Hexham Train Support Facility Modification 2

Ancillary Depot and Wagon Storage

State Significant Infrastructure Modification Assessment (SSI
6090 MOD 2)

Published by the NSW Department of Planning and Environment

Figure 4 | Flood impacts at areas 1 and 2 during 1% AEP (Source: Modification Report)

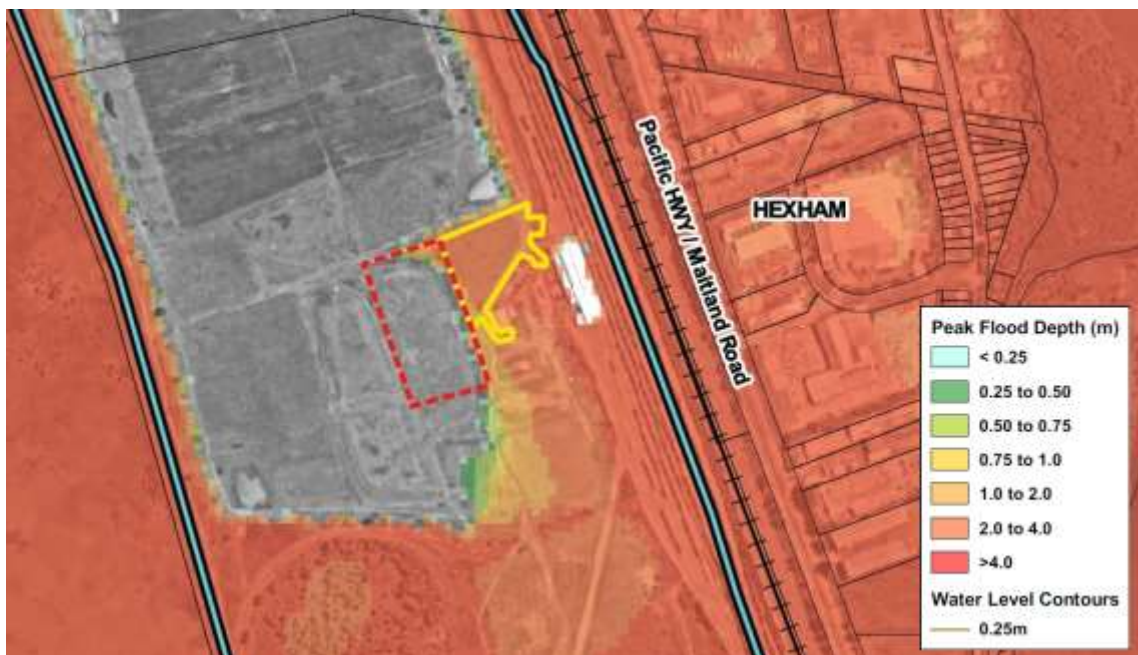
The Modification Assessments Report's Appendix F flood impact mapping (level and velocity impacts) compares the proposed development against the current base case. The results from the inclusion of the proposed development at the site was no off-site flood impacts would result from the modification.

The proposed development remains flood free during events up to and including the 1% AEP event, resulting in no flood impacts for these events. For the 1% AEP event with climate change the northern entry of the carpark is inundated, as seen by the incursion of floodwater into the Site shown above in Figure 4 The depot, warehouse and wagon stowage area are flood free during this event.

The Department notes that the assessment of the modification showed limited impacts on flood flow paths including in 1% AEP events.
